Addendum #1

Date: 3-19-25

Project: Crenshaw County Sportsplex – Phase 3

Architect's Project #22-42

2 TYPICAL WOOD STAIR - RUBBER TREADS
SCALE: 3/4" = 1'-0" (ACCESSIBLE)

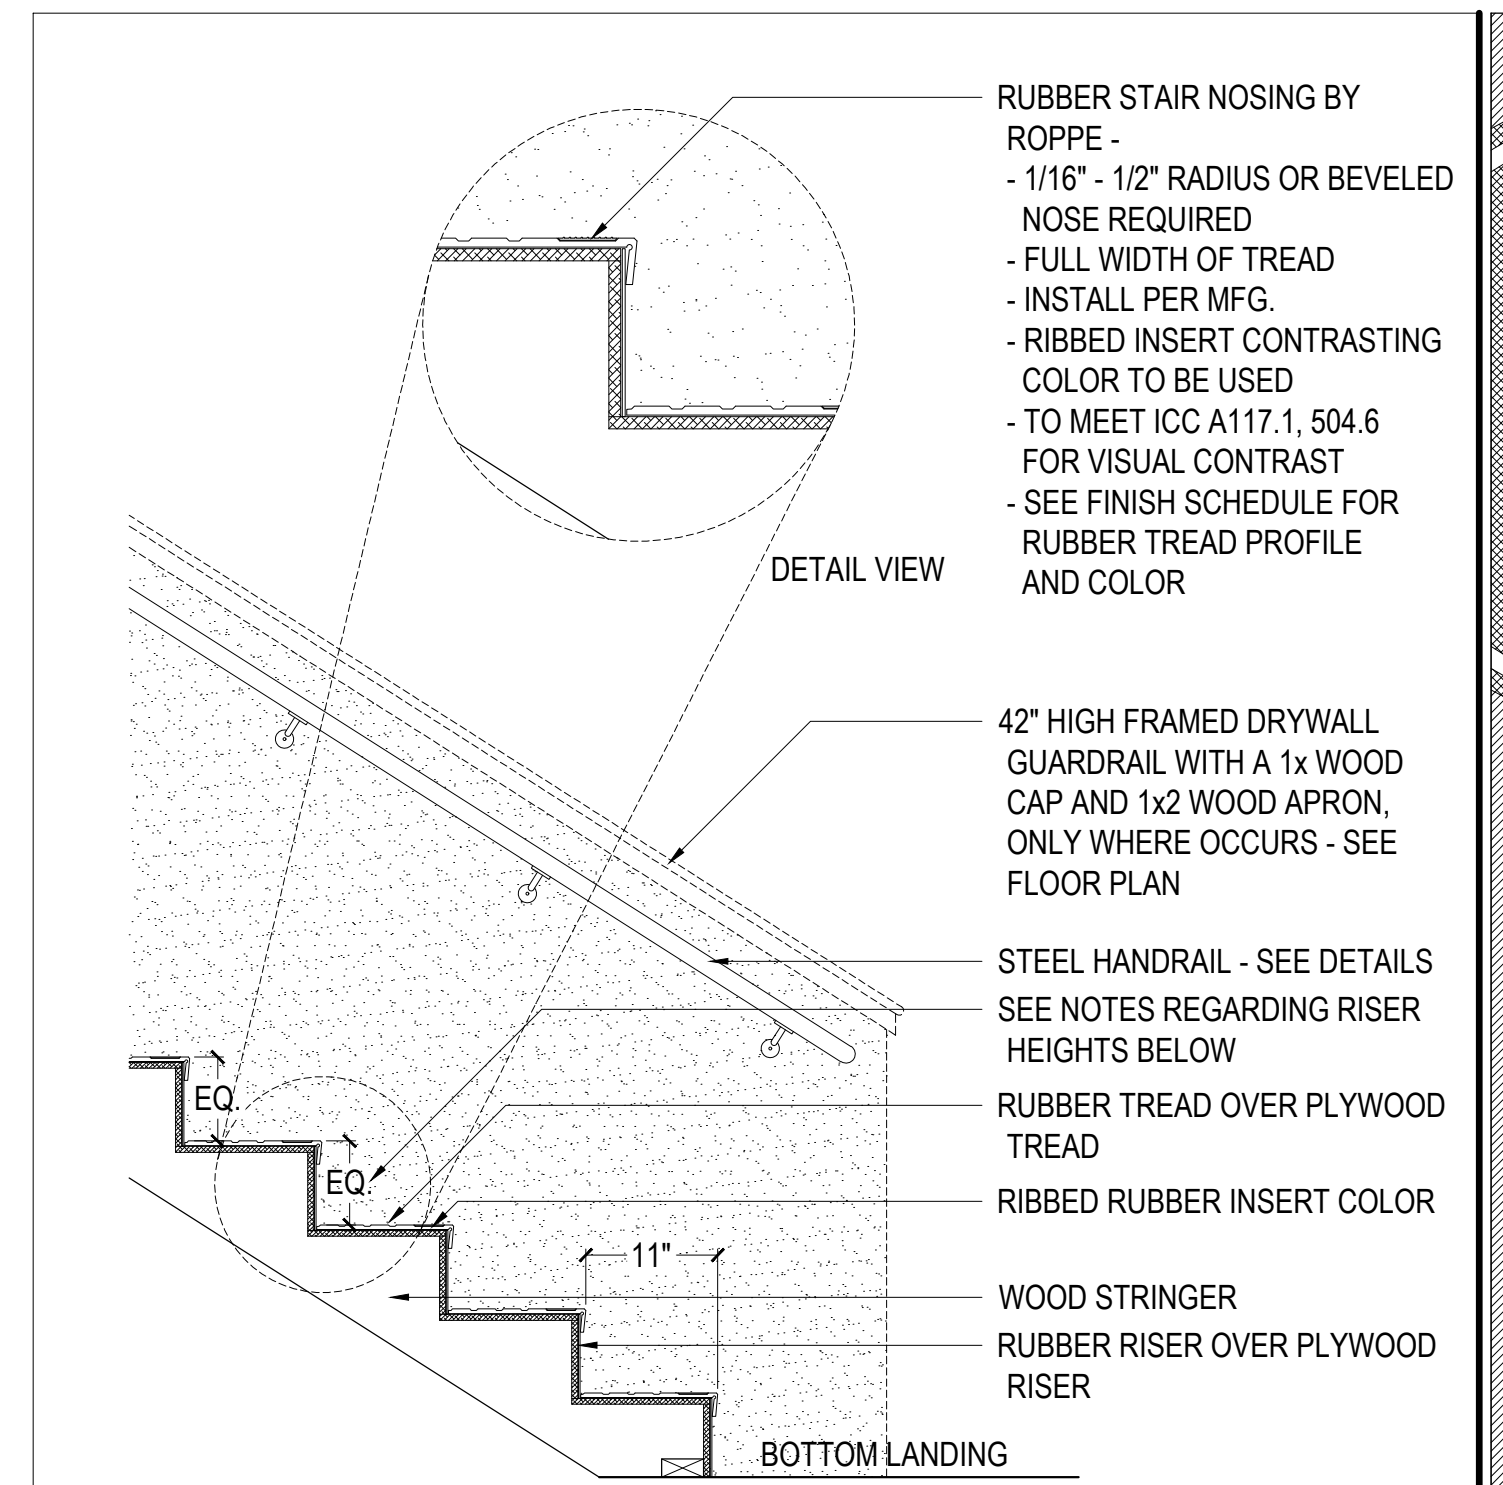
- a. A stair detail has been added to the drawings for the two interior stairways. While providing more information, the main purpose is to show the contrasting color rubber insert at the stair nosing. Color to be Almond.

- i. Detail 2/A5.2 – Baseball / Softball Concessions
 - ii. Detail 2/A5.2 – Football / Soccer Concessions
 - b. A stair detail has been added to the drawings for all exterior concrete stairways. While providing more information, the main purpose is to show the new stair nosing.

- RUBBER STAIR NOSING BY ROPPE -
- 1/16" - 1/2" RADIUS OR BEVELED NOSE REQUIRED
- FULL WIDTH OF TREAD
- INSTALL PER MFG.
- RIBBED INSERT CONTRASTING COLOR TO BE USED
- TO MEET ICC A117.1, 504.6 FOR VISUAL CONTRAST
- SEE FINISH SCHEDULE FOR RUBBER TREAD PROFILE AND COLOR

4 TYPICAL CONCRETE STAIR (ACCESSIBLE)

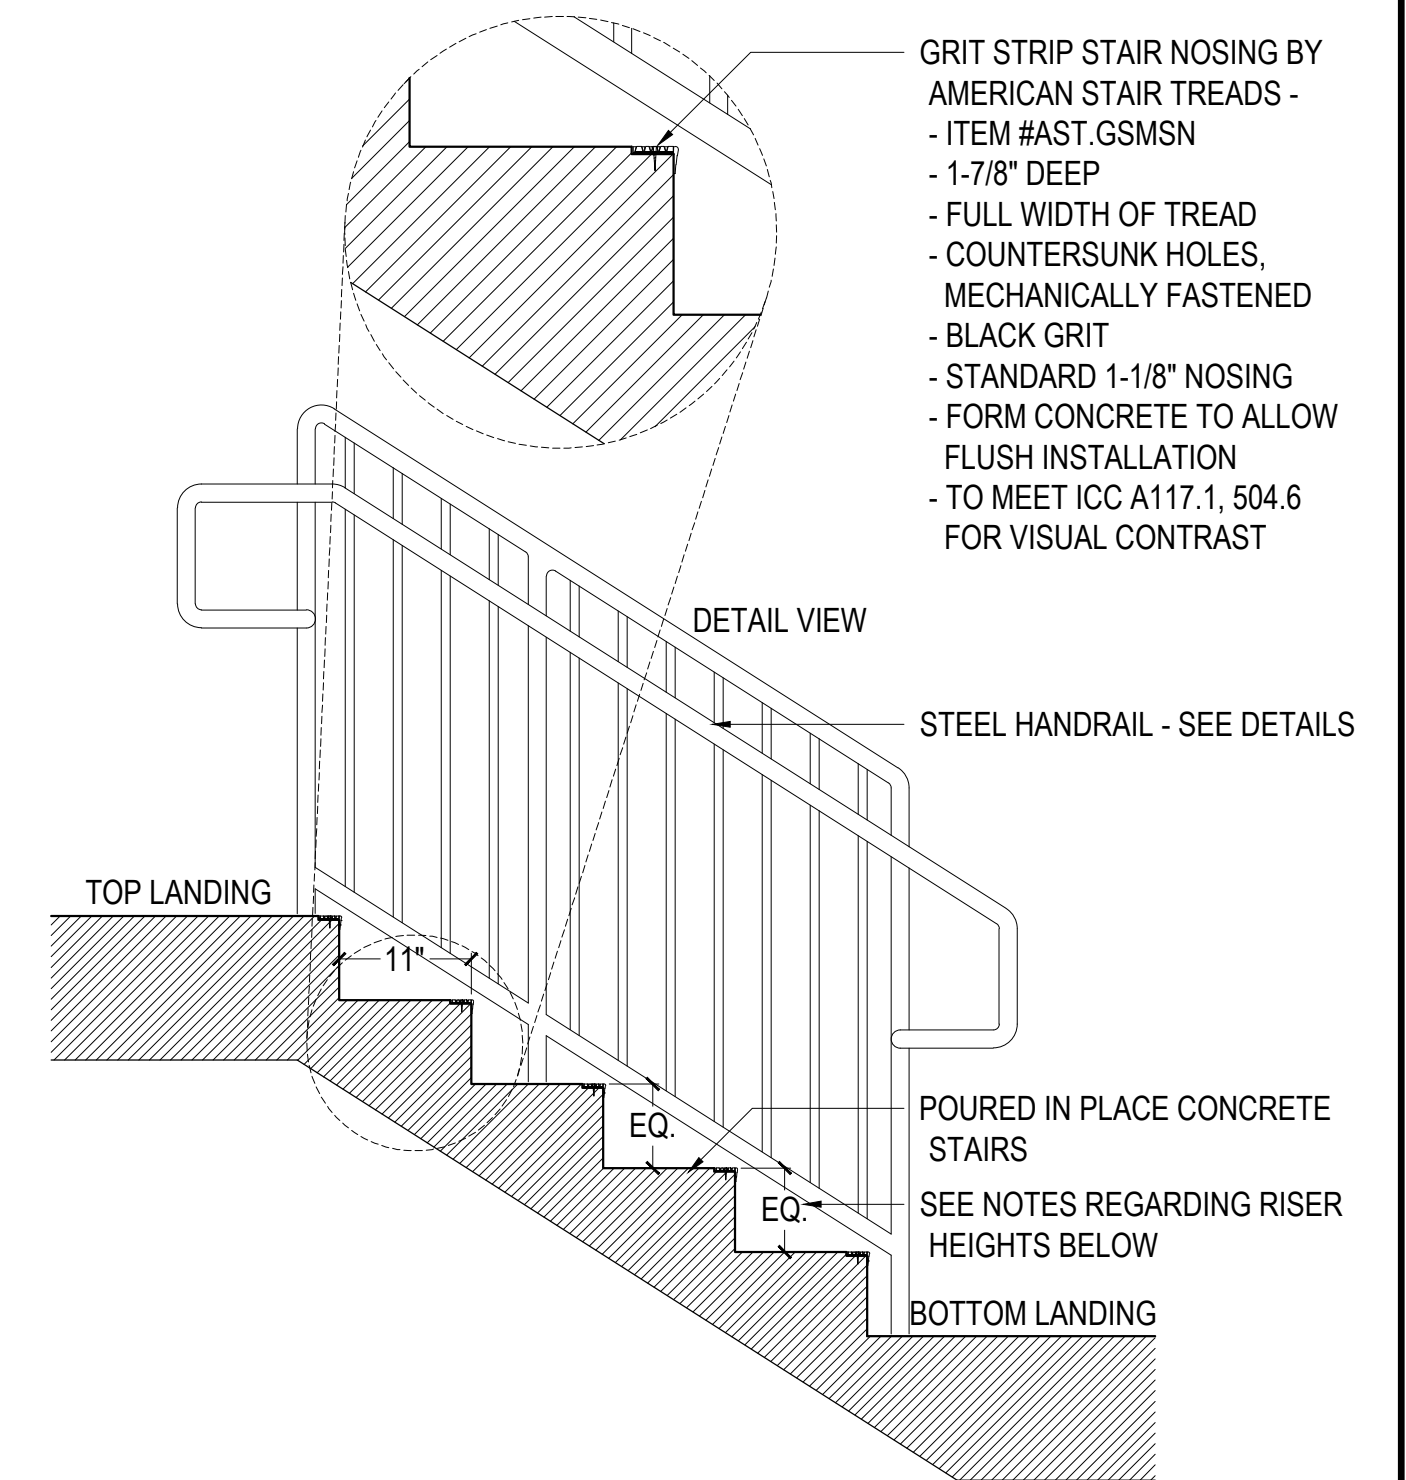
- i. Detail 4/A5.3 – Football / Soccer Concessions
 - ii. Detail 5/A5.4 – Track and Field Facility
- 3.) What thickness decking should be used on the 2nd floors?

DRAWING SHOWS A TYPICAL CONCRETE STAIR DIAGRAM, NOT A DEPICTION OF THE ACTUAL STAIRS. RISERS TO BE EQUAL HEIGHT, BETWEEN 4" TO 7" TALL. TOLERANCE BETWEEN THE LARGEST AND SMALLEST RISER SHALL NOT EXCEED 3/8" IN ANY FLIGHT. HEADROOM CLEARANCE SHALL BE 80" MINIMUM. MAXIMUM VERTICAL RISE OF 12' BETWEEN FLOORS OR LANDINGS
